Access Compliance Report

Public Rights-of-Way

Intersection ID: 15254	Main Street: IDEAL_WY	Cross Street: PARK_RD	Location: NW
ADA ID: 47D5C46C0C6F	Ramp Type: Perp	Initial Pass/Fail: Fail	Overall Compliance: No
		Severity Score: 10

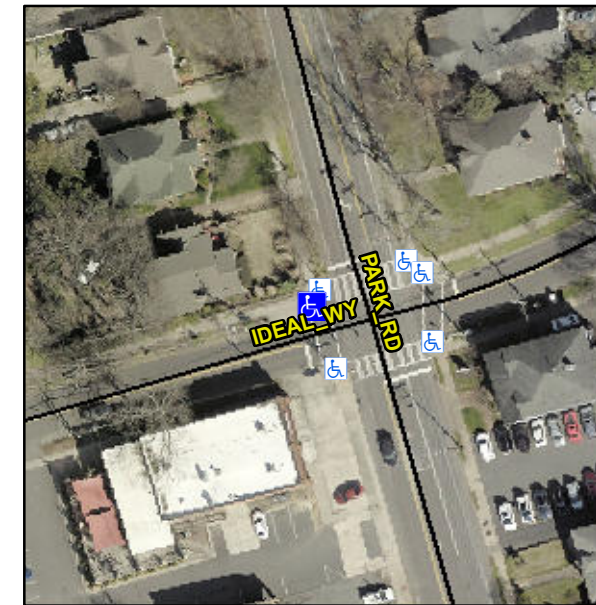
R304.5.1, R304.5.3

Compliance	Description	Data	Compliance	Description	Data
N/A	Ramp Length (in)	76.0	Yes	Ramp Slope (%)	5.2
No	Ramp Width (in)	36.0	No	Ramp XSlope (%)	4.4
N/A	Flare Type LT	N/A	N/A	Flare Type RT	N/A
N/A	Flare Slope LT (%)	N/A	N/A	Flare Slope RT (%)	N/A
N/A	Flare Traversable LT?	N/A	N/A	Flare Traversable RT?	N/A
N/A	Landing Length (in)	N/A	N/A	DWS Provided?	N/A
N/A	Landing Width (in)	N/A	N/A	DWS Contrast?	N/A
N/A	Landing Slope (%)	N/A	N/A	DWS Length (in)	N/A
N/A	Landing X Slope (%)	N/A	N/A	DWS Full Width?	N/A
N/A	Landing Curb? (Y/N)	N/A	N/A	DWS Offset (in)	N/A
N/A	Shared Landing?	N/A			
N/A	Gutter Ponding?	N/A	N/A	Gutter Slope (%)	N/A
N/A	Gutter Lip Ht (in)	N/A	N/A	Gutter X Slope (%)	N/A
N/A	Painted X Walk1?	Yes	N/A	Painted X Walk2?	N/A
	X Walk 1 Direction	To S		X Walk 2 Direction	N/A
N/A	X Walk 1 Width (in)	108.0	N/A	X Walk 2 Width (in)	N/A
	X Walk 1 Slope (%)	2.9		X Walk 2 Slope (%)	N/A
	X Walk 1 X Slope (%)	2.5		X Walk 2 X Slope (%)	N/A

Remove & Replace Entire Ramp.
